SMP Coastal Panel Meeting 12: Draft Coastal Adaptation Plans

Review and sign-off of draft Coastal Adaptation Plans for submission to the SMP Committee of Council and public consultation.

PU125 – Tairua River East

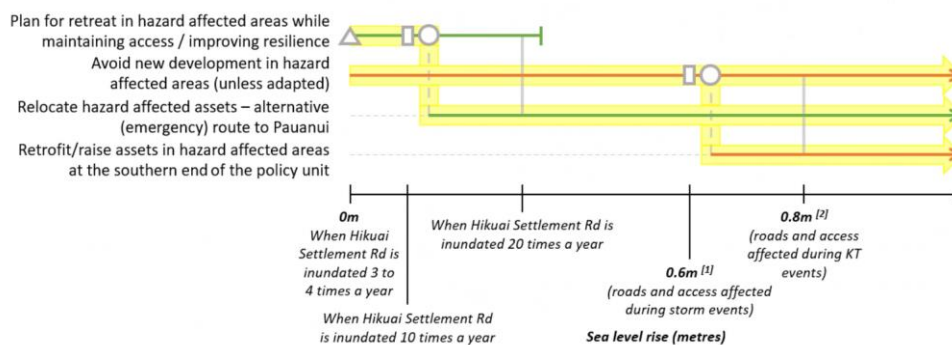
Needs further clarification.

Do the pathways fit the issues in this area? Flooding around Settlement Rd is fluvial rather than coastal.

SJ – we need to ensure that the road is raised as an appropriate time.

EC – gas stations need a long lead in time to any changes/retreat

Action: Pathway needs to be re done to make it clearer

AM – we need to raise the road (floods 3-4 times a year) so it doesn't get worse.

AC – note that there is a fluvial component on the pathway

VS – area of road where it dips down is very low and would flood too

PU127 - Pauanui Beach

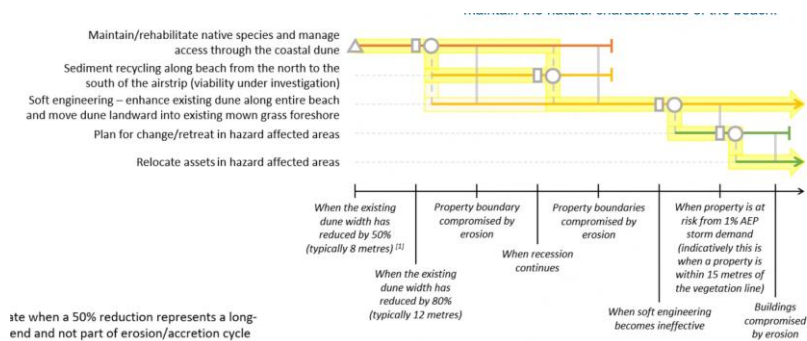
SJ – feedback for Pauanui has been strong and diverse e.g. natural, soft engineering, rocks etc

PS – looking at the significant event in the last 2 years, thinks Pauanui has nothing to worry about. Terminology should be 'if' not 'when'.

EC – step of moving houses is missing from the chart.

Consider the person buying the house, is it better to indicate retreat may be required, or leave it open

MP – leave it open

EC – leave it open – the choice should be there – need to warn people about retreat

SH - I would like to support planned retreat as opposed to rocks....keep one option open

PS – another option is just to leave it – the beach will rehabilitate itself – natural engineering. If we rush in and do soft engineering – we may be spending money we don't need to.

VS – from the point of view of ratepayers, it might be helpful to give an idea of cost of options in the short- and long-term solutions.

PS – keep options open (3 options)

JM – thinks options are too tight – maybe other options in the future – keep it open

SH - I think managed retreat should be signalled so that investment is not encouraged in problematic areas/ on risky sites

AM – in the pathway provide both options, but in the words indicate that there maybe a small number of properties that may need to be retreated.

PU136 - Wentworth River East

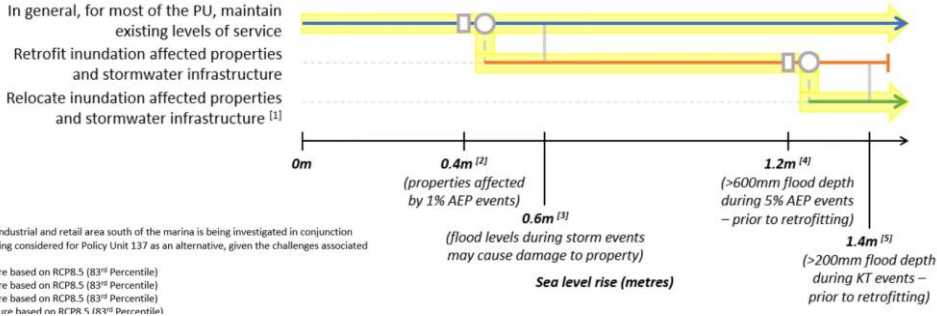
CS – in the absence of having an alternative for the light industrial area, you have no other option than to protect it.

This location won't be impacted for some time – so may not need defending for 70 years – but we don't have 'defend' on this pathway. Do we need an alternative? E.g. defend or retreat.

CS – need both options – if not a risk until then, it is premature to decide so keep the options open to decide then

PU137 - Whangamata Marina

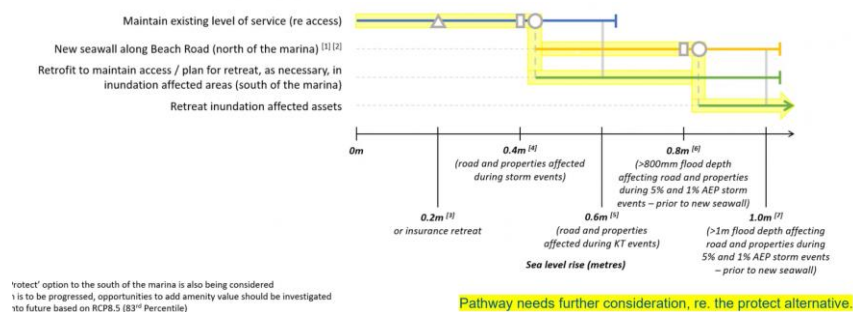
There is a connection between these two PU's. Protection will work up to 0.8m when water would come in from the back which would restrict access, therefore if the prior PU is defended it would protect this area too.

CS – totally agrees with protecting the industrial area which would provide protection to this area as well.

PS – would be in danger of losing the sand on the south side if a hard structure put in place. Any change here will affect sediment transportation which will affect the bar.

AM – does strategy recognise the need to manage the risks associated with action taken here.

SJ – we would need to consider the effects, and closely look at design

PU138 – Outer Whangamata Harbour

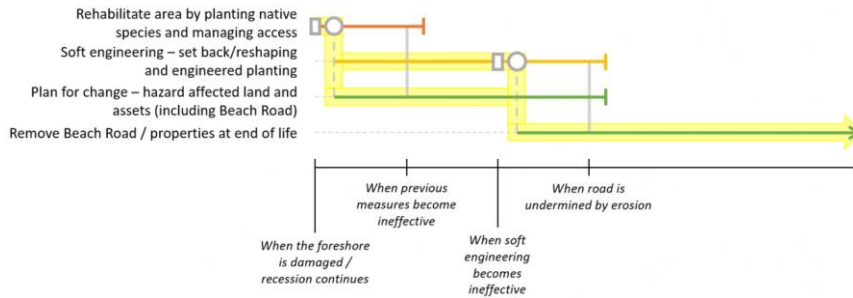
CS – has done a lot of surveys in this area. Historically almost eroded back to the road, groynes put in in early 80's, sand put in to widen. Up until last year it hasn't been unstable as it was historically. Area has been tinkered with over a long period of time – if we removed the groynes and left it to nature the access to the property owners at far end would not have access.

PS – doesn't agree with the dredging that goes on, (content of dredging). If you push the beach out on that point it will draw the flood tide on the other side and narrow the channel (increase the velocity of the water).

EH – are we removing part of Beach Rd to restore back to dune planting.

SJ – what we are saying now – advocating now for maintaining the groynes and recharging with dredged material

CS – road staying, maintain the groynes, soft engineering and dune planting (if road is in danger)

PU139 – Whangamata Beach North

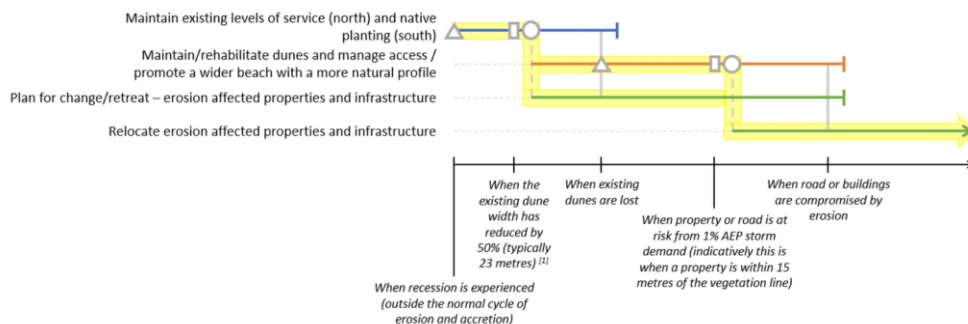
PS – trigger point at 23m is appropriate as provides a good buffer. At northern end of beach when there is a strong swell there is a spur that goes into the estuary, long term drift of sand is good for the beach at the moment.

EH – is there any advantage if the Esplanade carpark was planned to be returned to a dune area for resistance.

PS – thinks this is naturally happening and creating its own undulating dunes.

PU140 - Whangamata South

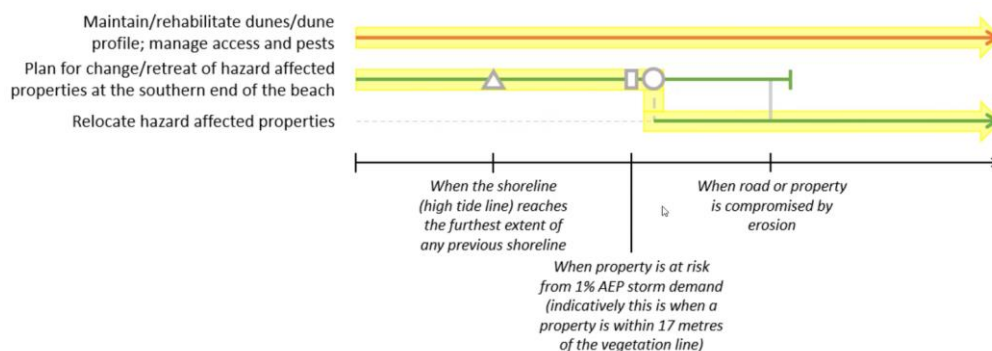
JB – ‘natural defences lost’ is not the right term, they will still be there, but perhaps ‘squeezed’ is a better term

PS – storm water outlet put in seems to have dissipated the surf coming straight in there.

CS – what has the response been from the beach front property owners to this suggestion? Similar to Pauanui?

PS – we haven't mentioned artificial reefs out from the dunes – no advocacy for this

SJ – maybe we need to word similar to Pauanui

Sorry my computer view of chat is tiny. Prior no longer in my view the wording indicated to me trigger for planning to increase dune staking car park was after road was being undercut. In my view this trigger for this decision should be earlier. Would just like it checked thanks.

PS – doesn't agree a big storm would take them out
NL – hasn't been a 1%AEP in this area for some time/long time
AM – check 1% AEP storm demand – is this the right level of storm we want to retreat from?
17m is a lot of room in front of the property to think about retreating now. A storm of that magnitude may not happen for 100 years. Need to check the method.
JM – can we change wording to 'prepare' for retreat
SJ - we are saying 'plan' for retreat rather than retreat now
Sharon Harvey - Something needs to be signalled because millions of dollars are still being invested in those properties. But isn't the issue also new investment?
Eleanor Haughey - Is there a step to advise architectural protection of property foundations sand returning private property to dune at the 1% AEP 17m point in between retreat option?
All agree discouraging development in risk areas.

SJ – is there something else we should be doing now? JB – should be the same as Pauanui
SJ – retreat or defend?
AM – giving a choice in Pauanui – to be consistent, we need to do that here too.

CS – agrees it should be the same as Pauanui
SJ – Pauanui we justified in saying it was a long time off yet, so didn't need to make a decision – this one is happening now – we need to make a choice now. SH agrees
JM – is TCDC prepared for people retreating now?
SH - I think we're advocating disincentivising investment in the first instance.
JB – says if you build in this zone, your house needs to be re-locatable – area is a little 'grey'

AC – 'Assess retreat readiness' is a good term to use
CS – discourage should be used rather than prohibit – if people have all of the information, then they should be able to make the choice.

Action – #1 need to look at this again – is a 1% AEP a too bigger storm to calculate on. #2 for the properties in that 17m now, what is the action, is it soft engineering?
